Overall comments to the editor and reviewers:

Anonymous Referee #1

Review #2 of “Hydrological Impacts of Global Land Cover Change and Human Water use” by Bosmans et al.

Hydrological impacts of global land cover change and human water use

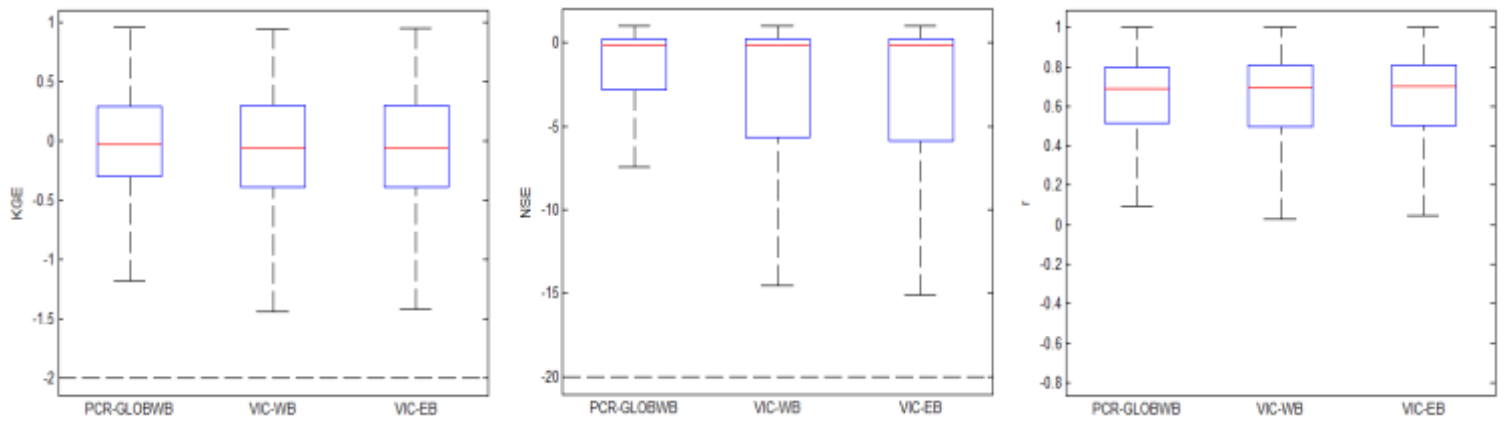
1. Energy balance. The authors discuss changes to ET using a model that does not contain a fully land-energy balance as many land surface models do. I think this may influence the findings of the work, particularly where the results show canceling out or reinforcement from land cover changes and the Budyko relationships. It would seem that exploration of the sensitivity (beyond what is in the SI) of this assumption on results would be important. I would like to see discussion of the impacts of the simplified approach used here contrasted with a more complete energy balance both in approach and with discussion on the impacts to the conclusions.

Results from a comparison between PCR-GLOBWB and VIC (both in water balance and full energy balance mode; WB and EB) in a master student's report indicate that while VIC-EB outperforms VIC-WB in some aspects of the water balance, the improvement due to the energy balance is small. Furthermore, PCR-GLOBWB scores are on average similar to both VIC versions. An example of comparing snow water equivalent of these models is given in Figure 3.

(b) Impact of water use (HUM2000-LC2000)

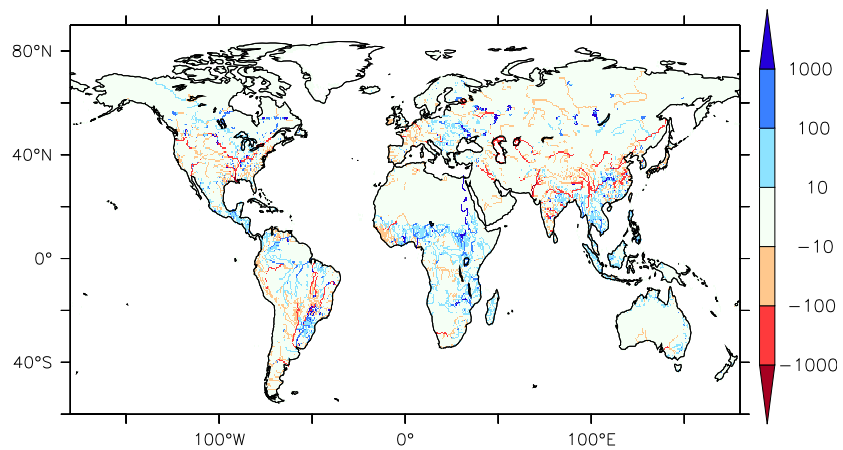
Page 11, lines 6-7: “as evapotranspiration is only increased over irrigated areas”. => This is an assumption made by the authors, however, in reality ET has also changed considerably in rainfed crops due to land use modification. *True, but here we refer to the comparison of experiments LC2000 and HUM2000 with have the same land cover, the only difference is that water is redistributed in HUM2000 (added to irrigated crops for instance). This will be clarified, e.g. by adding a reference to Figure 5b.*

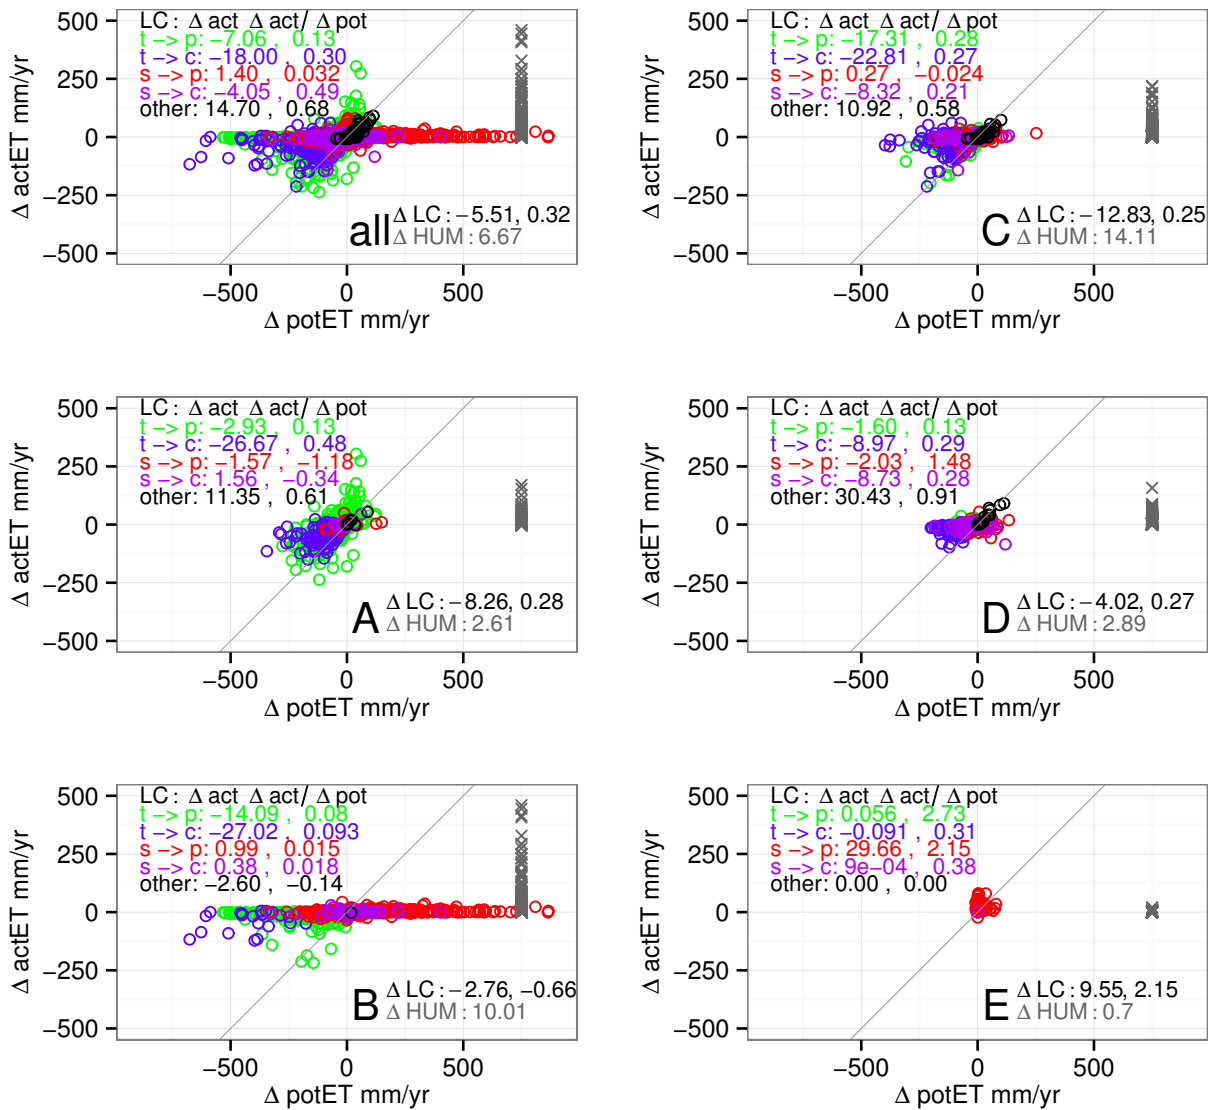
- Figure 9 : Only 1 basin seems to have significant ground water pumping as the arrow points above the actET=P line. Which basin is this and are there observations to give some credibility to this result ?

This basin is a drainage basin in North Africa, draining into the Gulf of Sirte. This area is very dry and thus water limited, hence potET is much larger than P and actET is naturally very close to P. In experiment HUM2000 the actET/P is only slightly higher than in LC2000, in this very dry area not much water needs to be added to reach actET>P. There are other basins

where the impact of human water use on actET/P is much greater (see grey arrows in Figure 9). Both surface and groundwater can be a source for additional actET.
